May 20, 2022

RE: Completeness Response – LU 2022-012 Chestnut Inn and Parkway Village South Self-Storage

Parkway Village South (Lots 1 and 2) Site Plan Review, Major Modification, Conditional Use Permit, and Lot Line Adjustment Applications

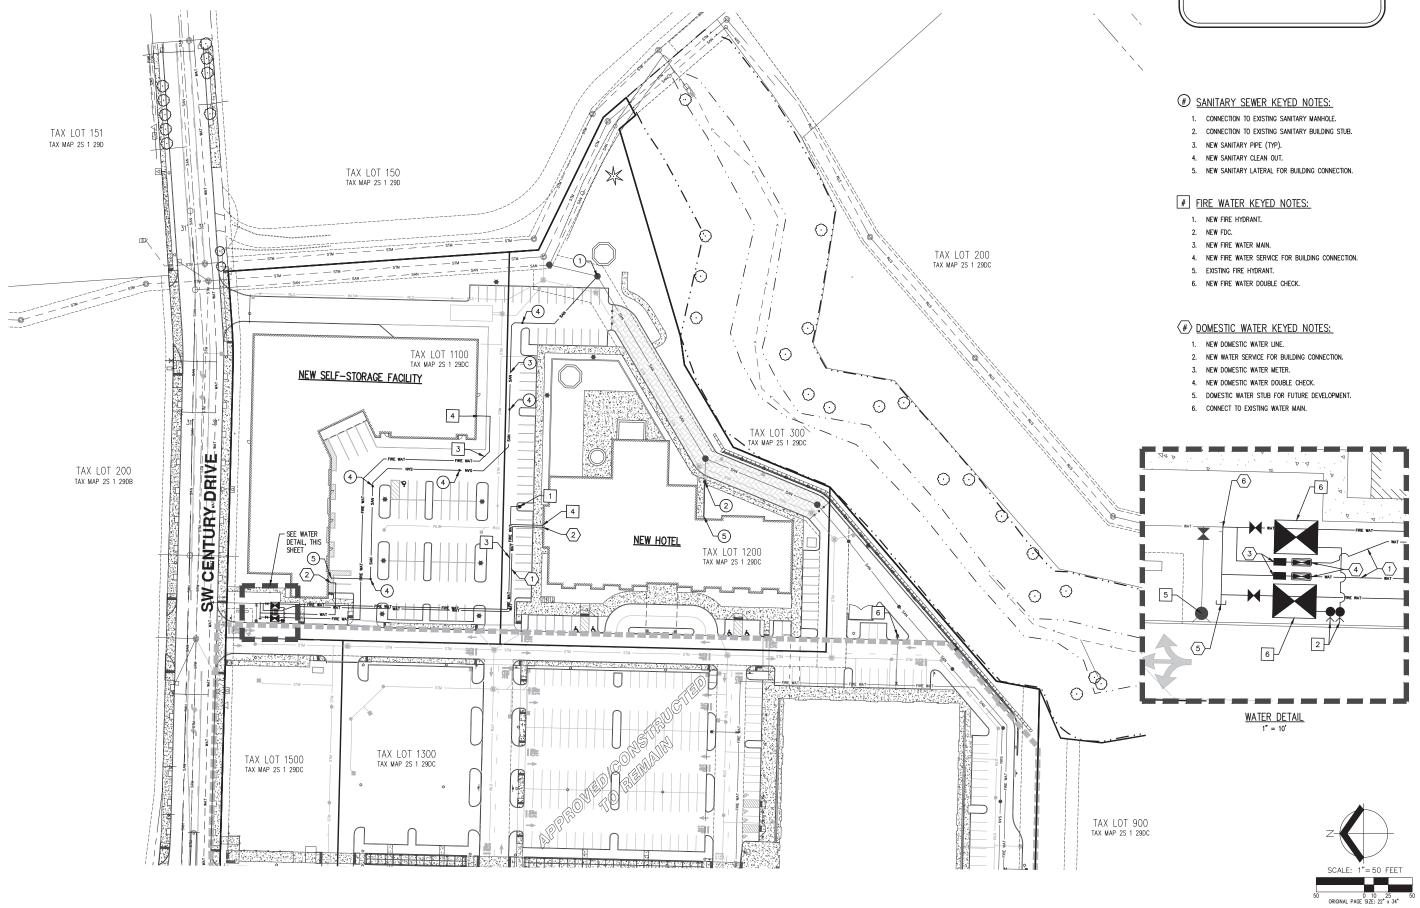
- 6. Revise the plans to show the intersection spacing for all driveways on Century Dr. on both sides of the street within 150 ft. of the property line.

- **<u>Response:</u>** Please see the updated Preliminary Dimensioned Civil Site Plan (Exhibit A), updated to show the intersection spacing for driveways on the north side of Century Drive. All of the requested information has been provided.

Exhibit R [NEW]: Parkway Village South Modification Explanation

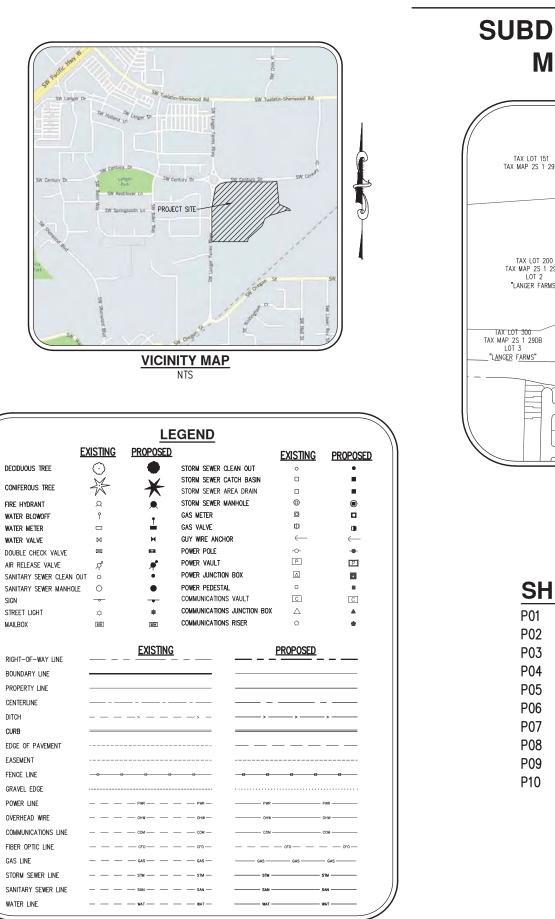
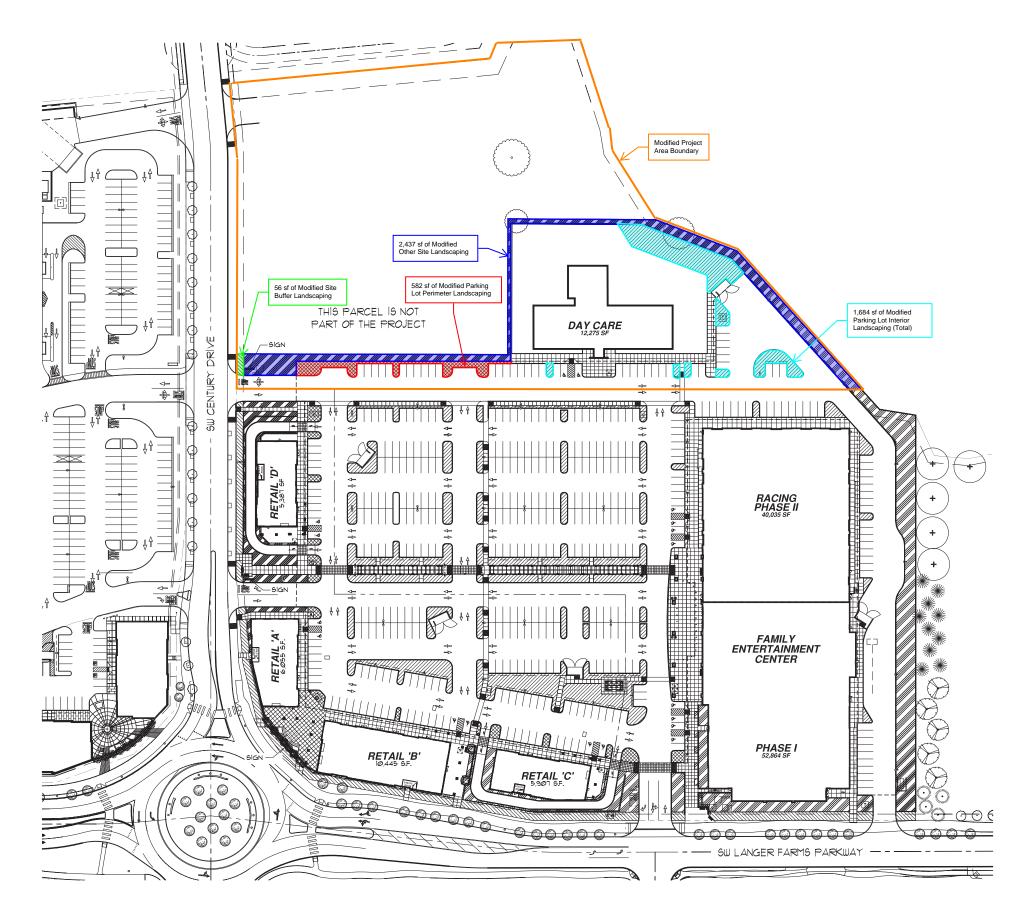
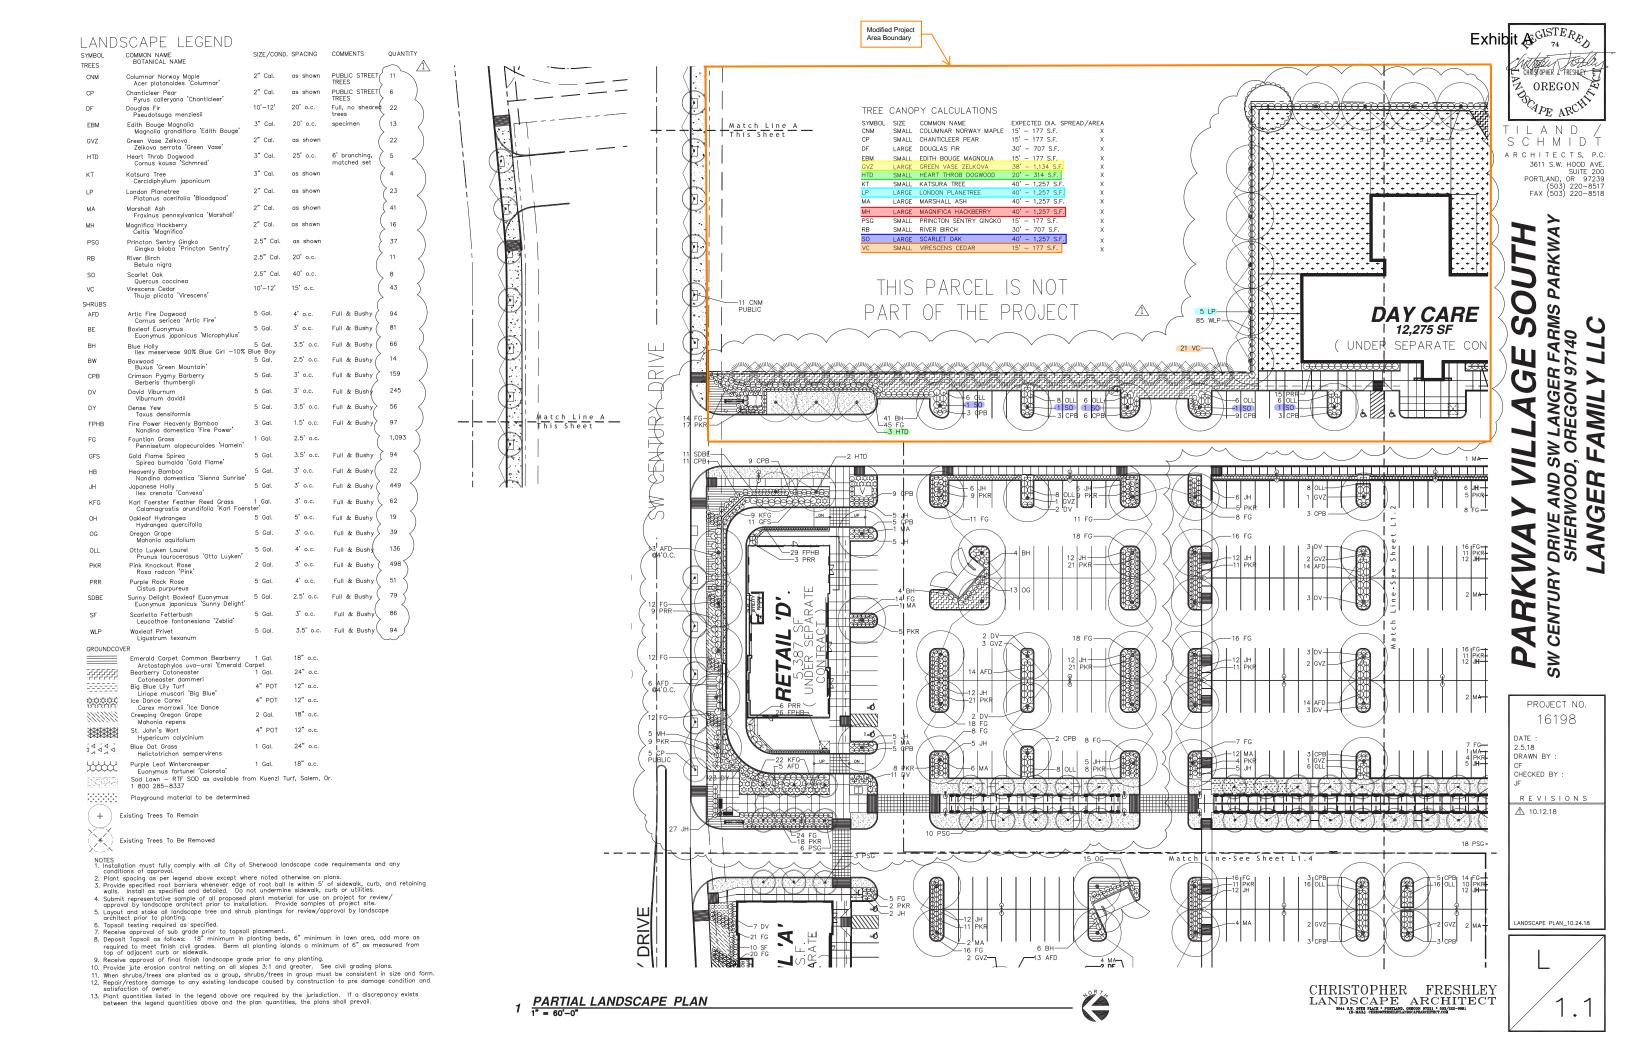
1. As part of the 2017 Site Plan and 2018 Minor Modification approvals, a shared approach for parking, landscaping, etc. was taken to show compliance with the development code standards. The proposed modification to Lot 2 will impact compliance with development code standards for Lots 3, 4 and 5. The application is required to demonstrate how all lots in Parkway Village South continue to meet development code standards with parking, landscaping, etc. being removed and modified on Lot 2. A shared approach can be taken to the entire development, or certain lots can be grouped together to show compliance separately. The CC&Rs recorded against the property

- Response:The above comment is understood. Please see the Parkway Village South Modification
Explanation (Exhibit R), containing calculations and associated parking and landscaping
modification exhibits. As demonstrated in Exhibit R, the entire site exceeds the required
amount of tree canopy, parking landscape area, and large trees. Additionally, the overall
landscape area (defined as "other site landscaping") also increases from the Minor
Modification approval (City File No. MSSP 18-08), showing 21 percent of the total Parkway
Village South site area is intended to be landscaped. Further, the Parking Landscape Area
Calculation sheet (Exhibit R) and approved Minor Modification plans illustrate the
changes made to parking stalls with this application. As noted, 41 stalls are modified from
the previous Minor Modification on Lot 2, and 118 parking stalls are provided on Lots 1
and 2 with the current Major Modification. A shared approach to parking will continue to
